March 24, 2023

**NOTICE OF ADDENDUM
ADDENDUM NO. 2**

**CONTRACT NO. 9226, PROJECT NO. 12393
Phase 2 CCB City Office Remodels, First and Fifth Floors**

SCALE	
PROJECT NUMBER	210101
SET TYPE	PLAN REVIEW
DATE ISSUED	12/22/22
SHEET NUMBER	E202N

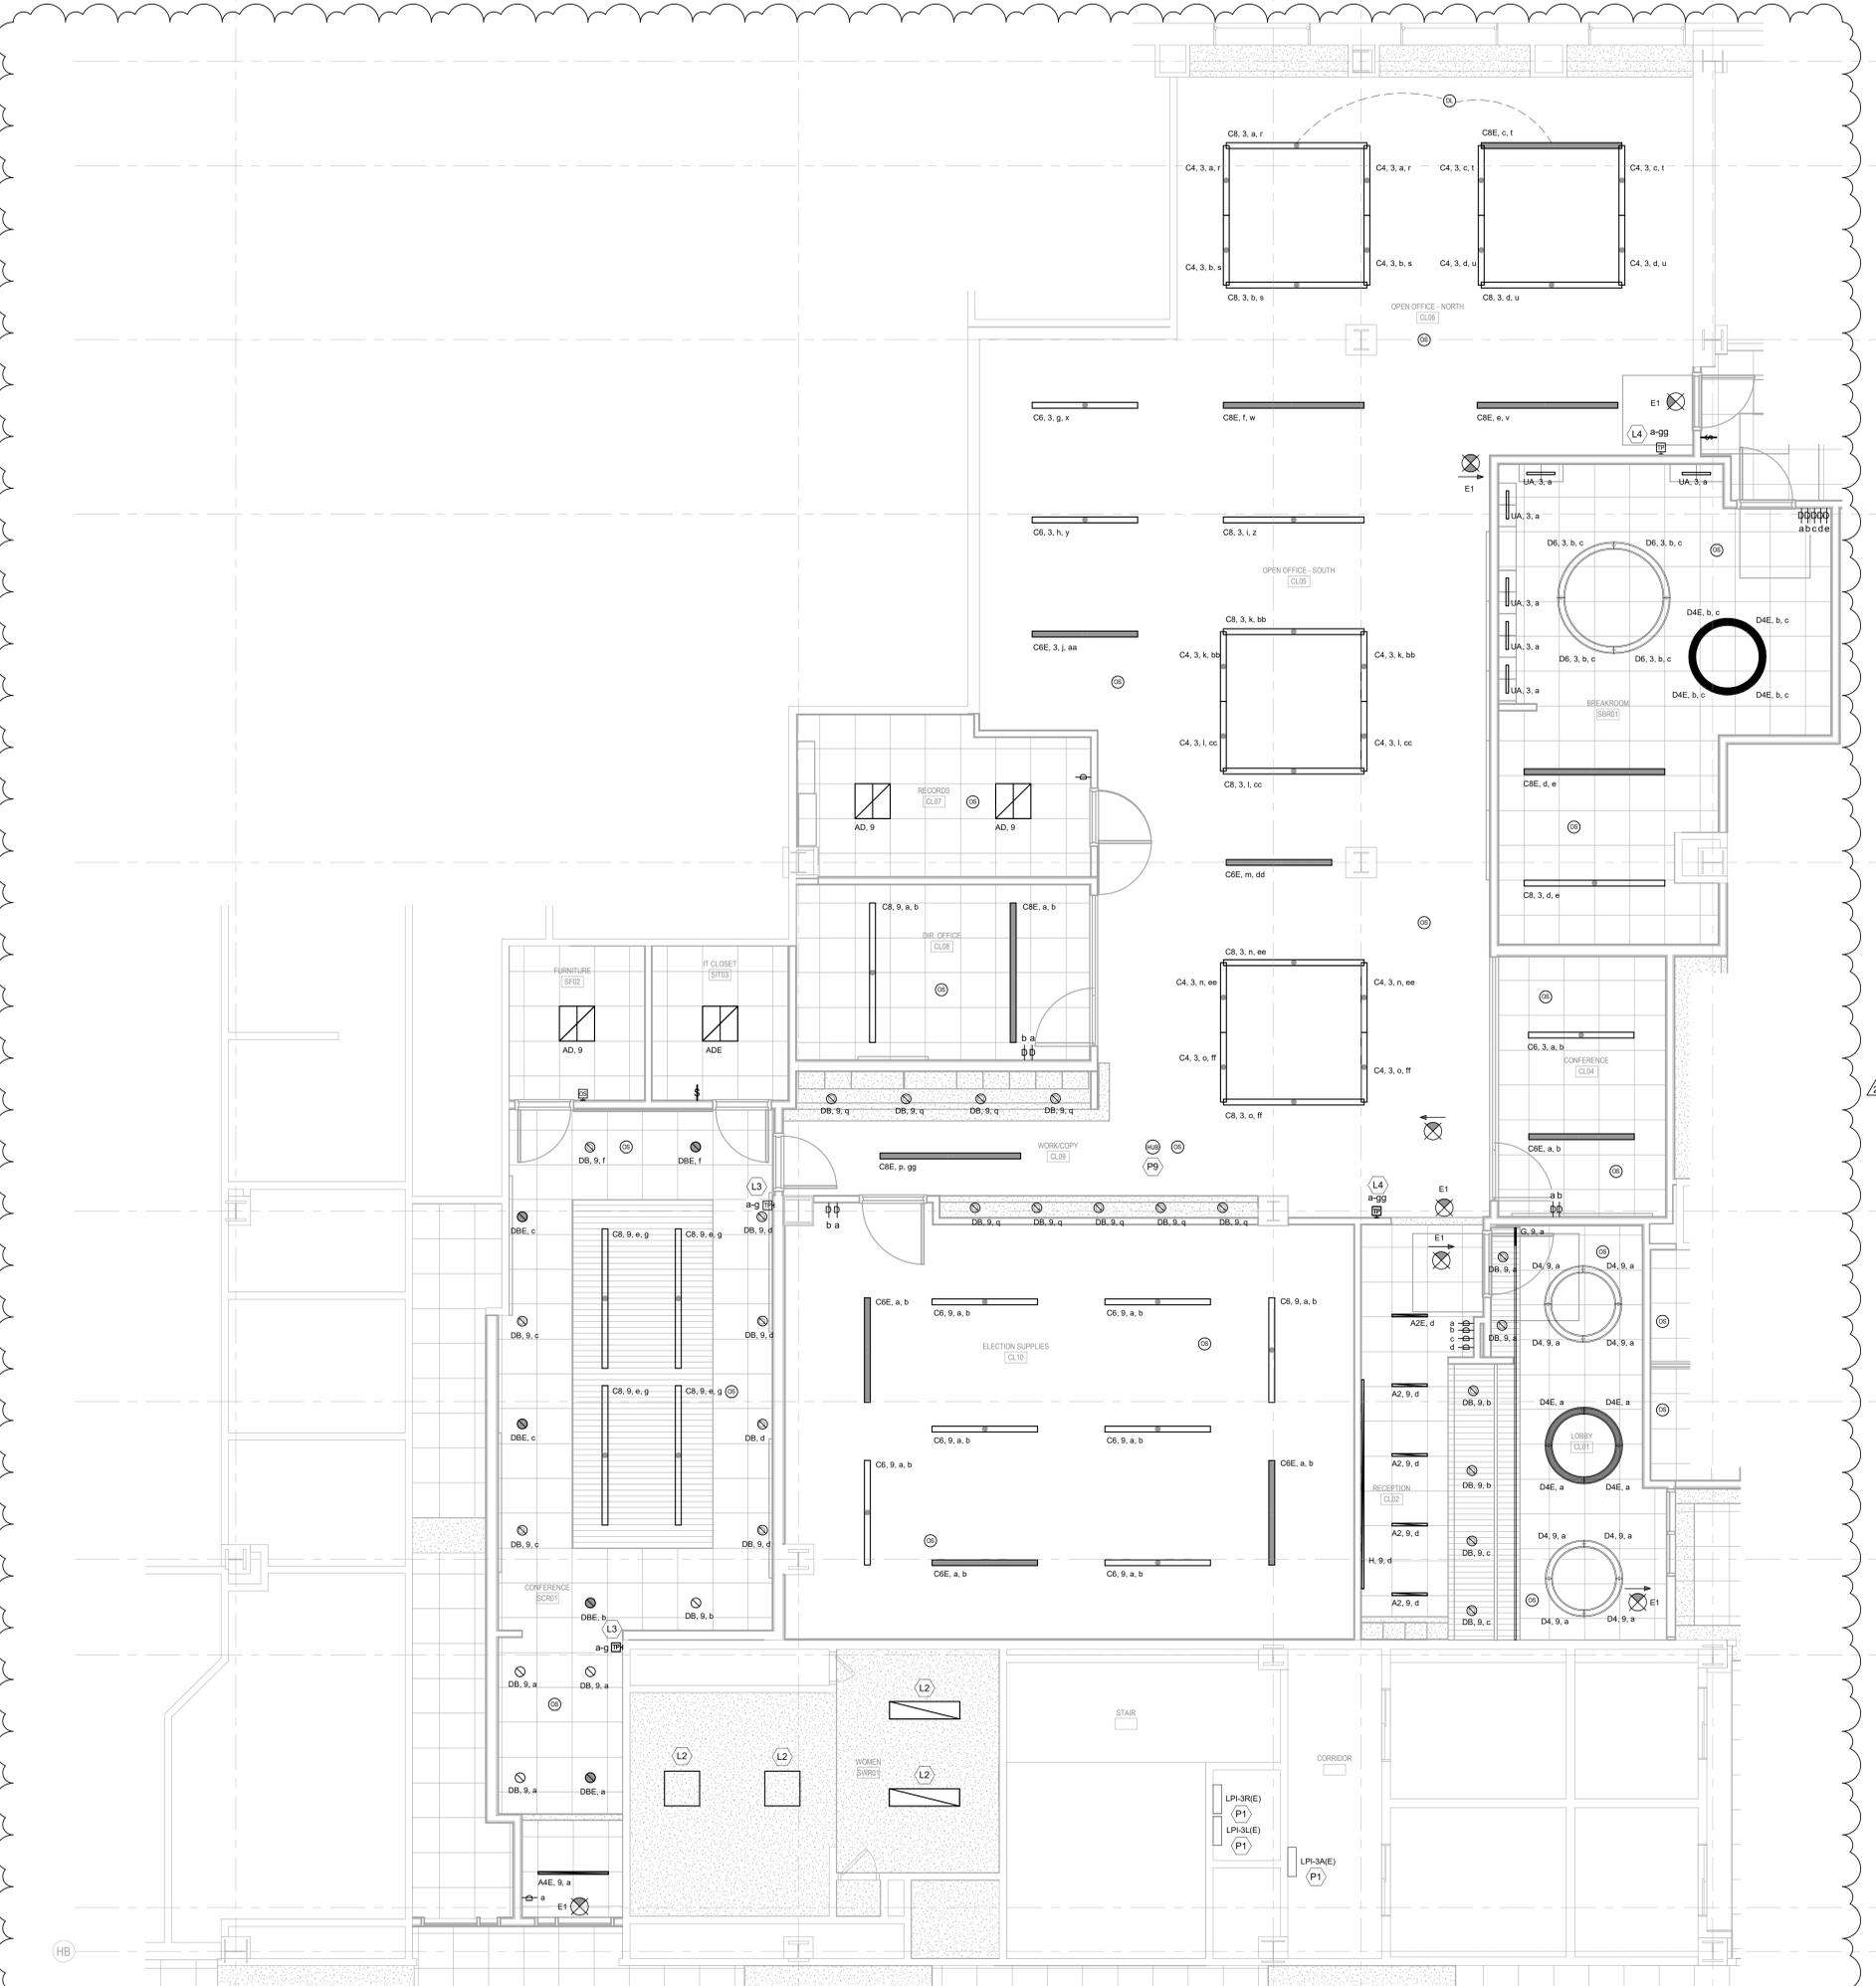
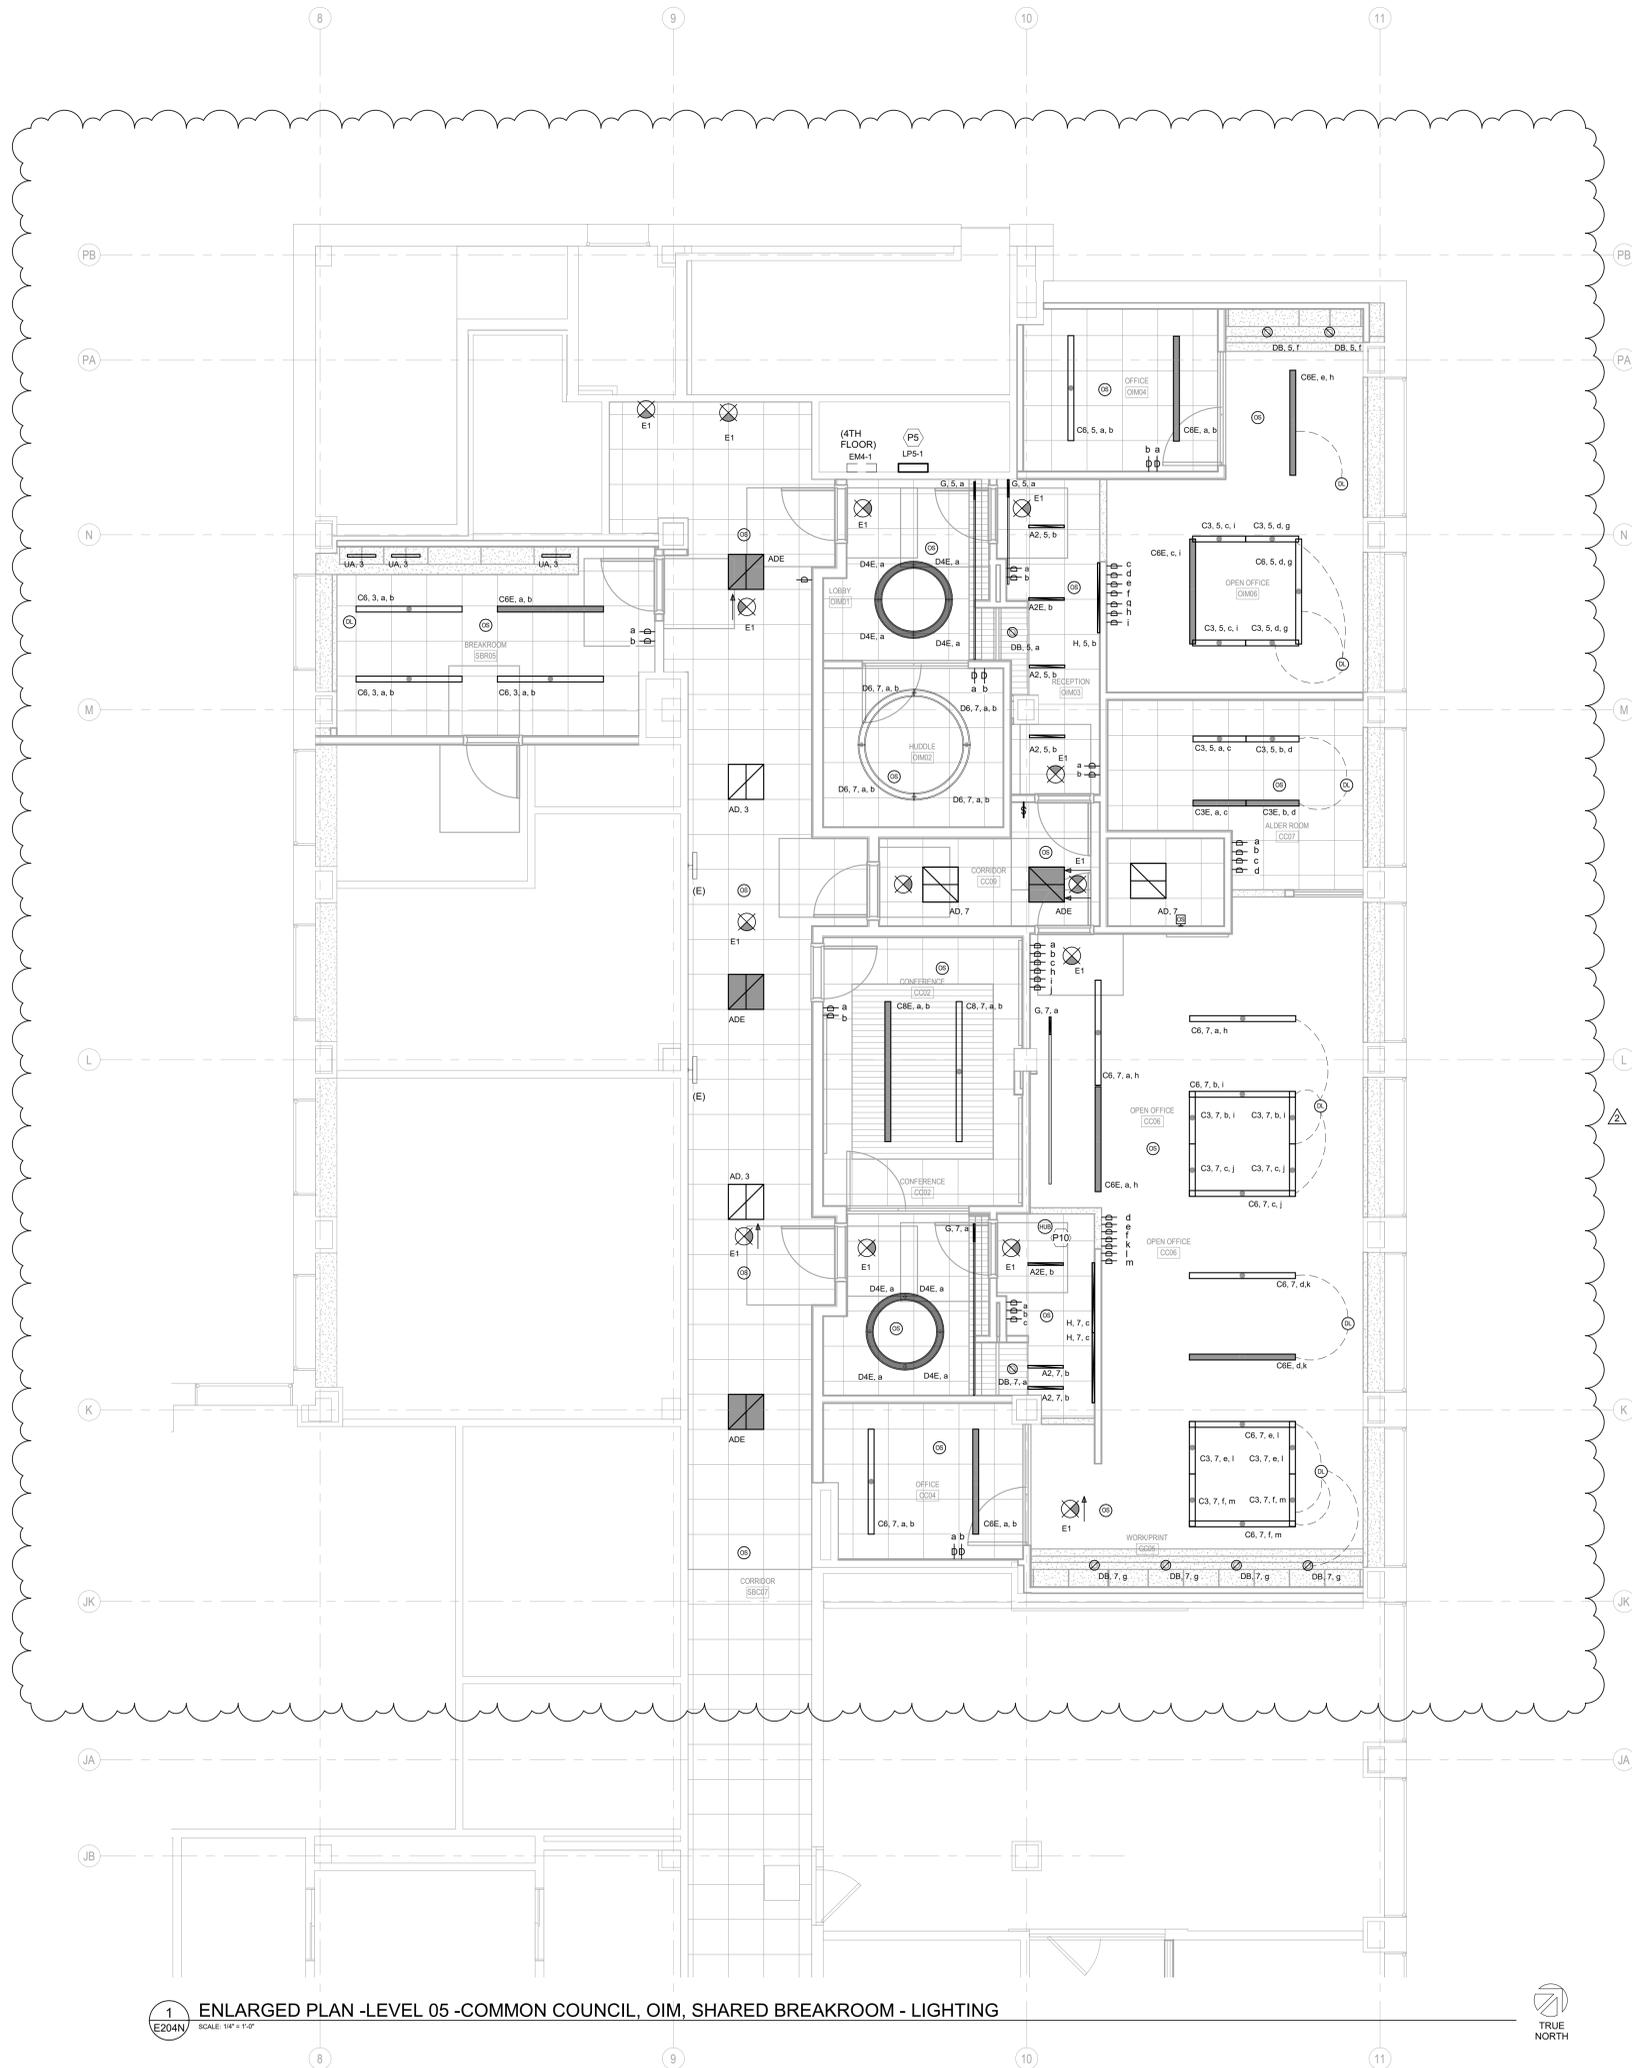
7. Sheet E202N – Revise the switching of all type C6, C6E, C8, and C8E fixtures as shown. Revise the switching of certain type D4E and D6 fixtures as shown. Add additional dimmers accordingly as shown. Modify certain touchpads as shown. Modify certain type C8 fixtures to type C4 fixtures as shown. Amend keyed notes L3 and L4 as shown.

SCALE	
PROJECT NUMBER	210101
SET TYPE	PLAN REVIEW
DATE ISSUED	12/22/2022
SHEET NUMBER	M301N

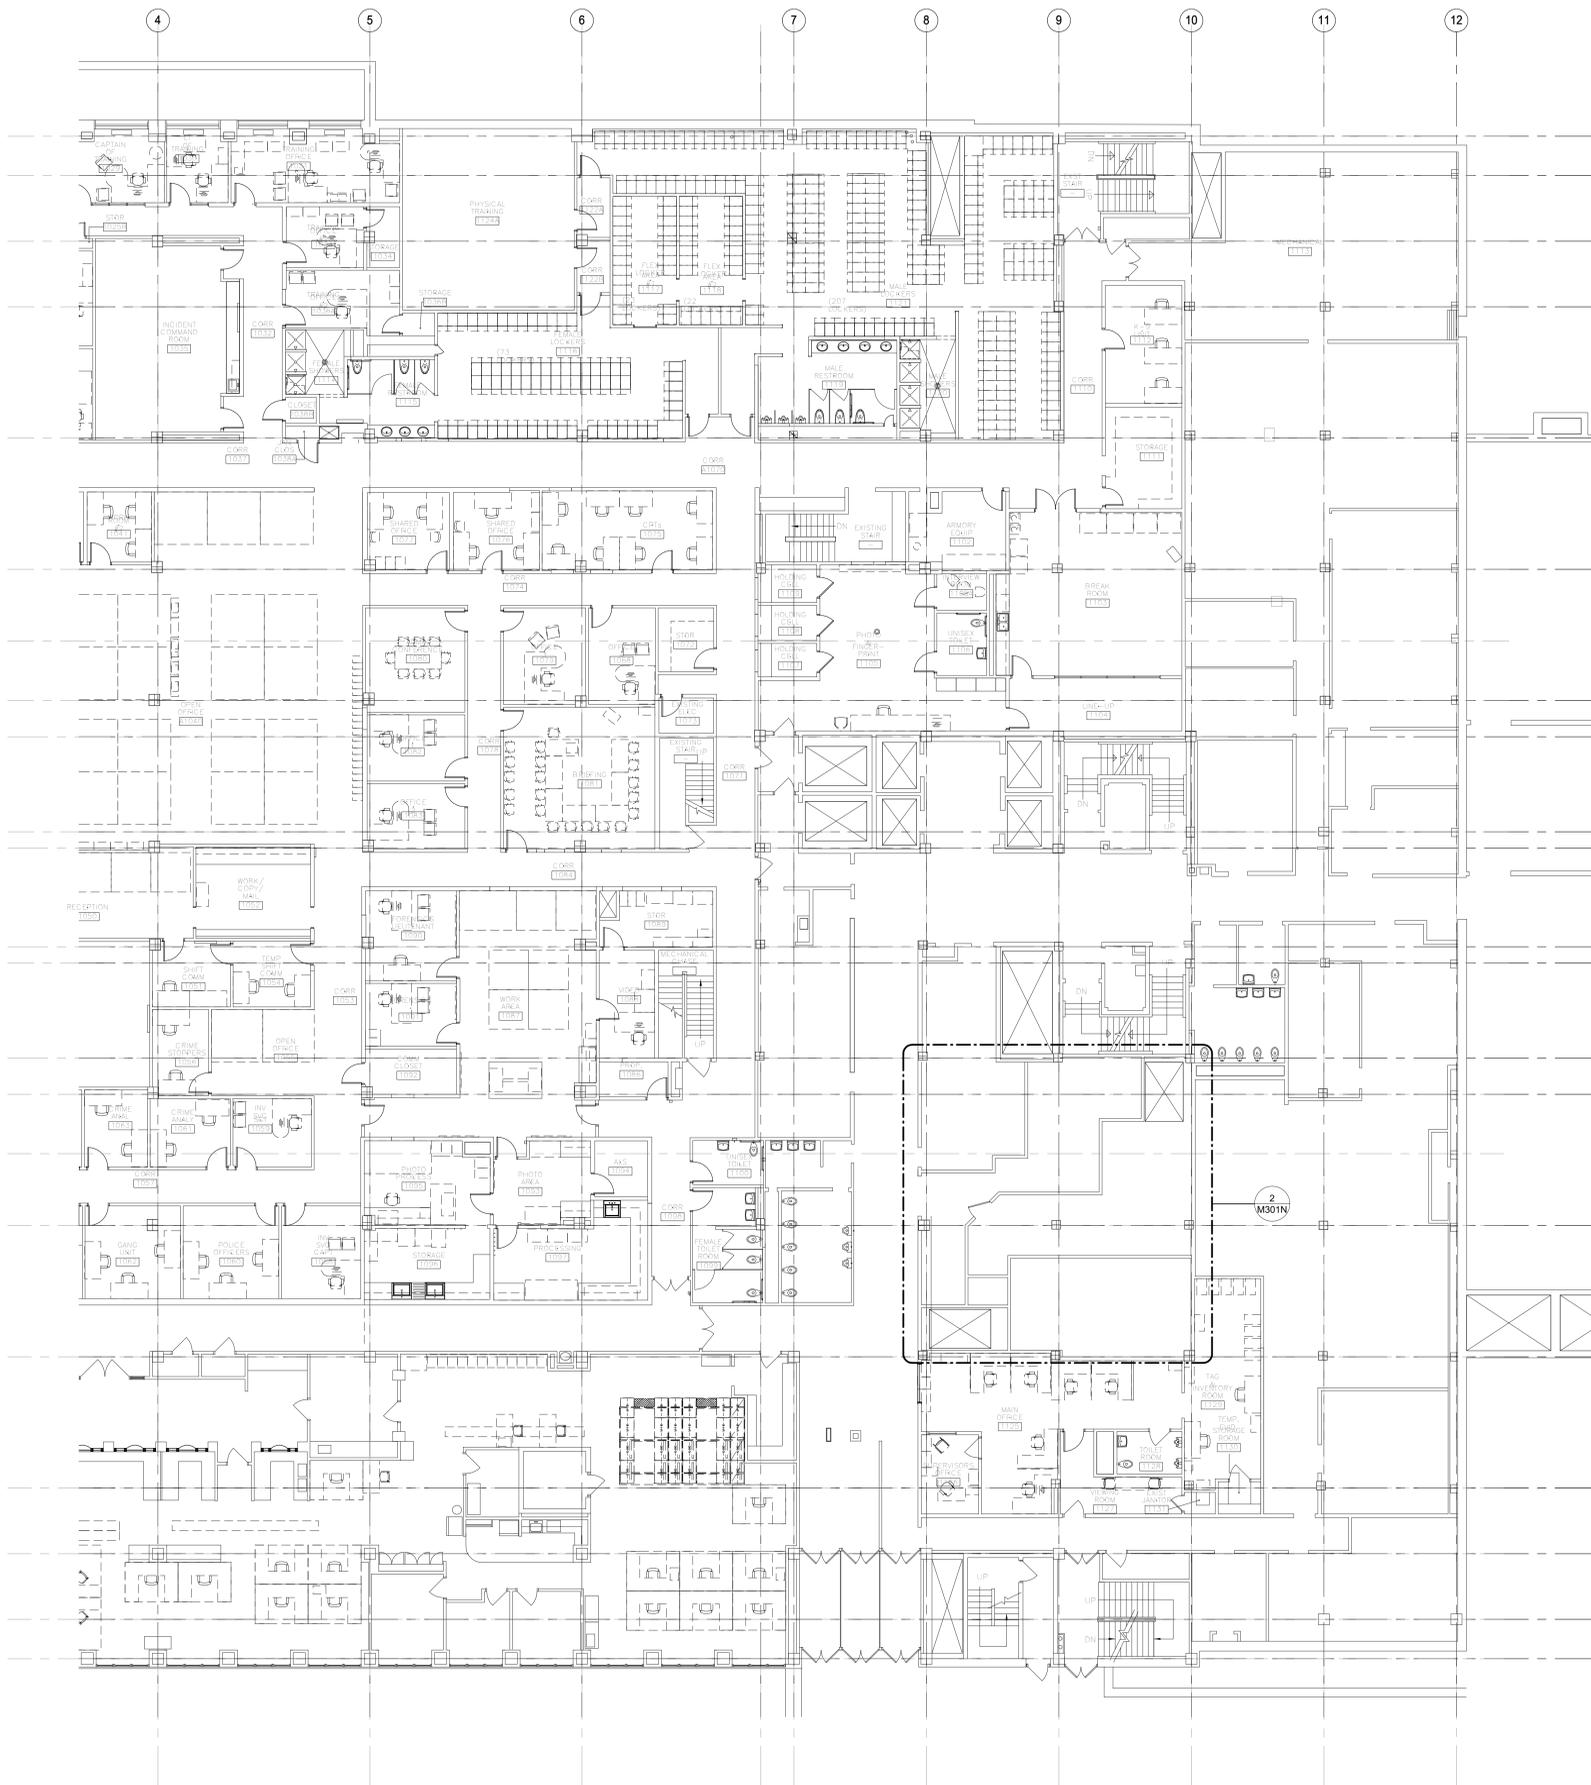
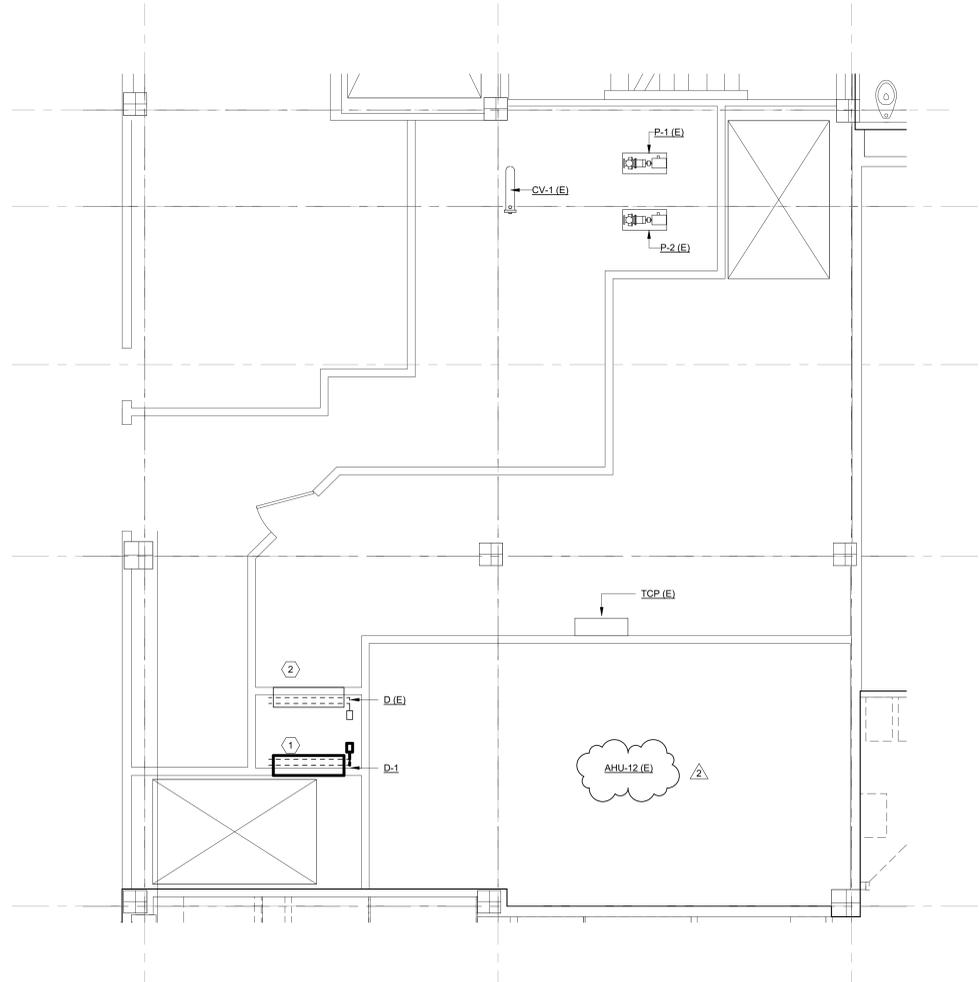
1. Sheet M301N – Revised the existing air handler ID number.
2. Sheet M302N – Revised the existing air handler ID number.
3. Sheet M501N – Revise keyed note 1 as shown. Existing pump housing and impeller to be removed.
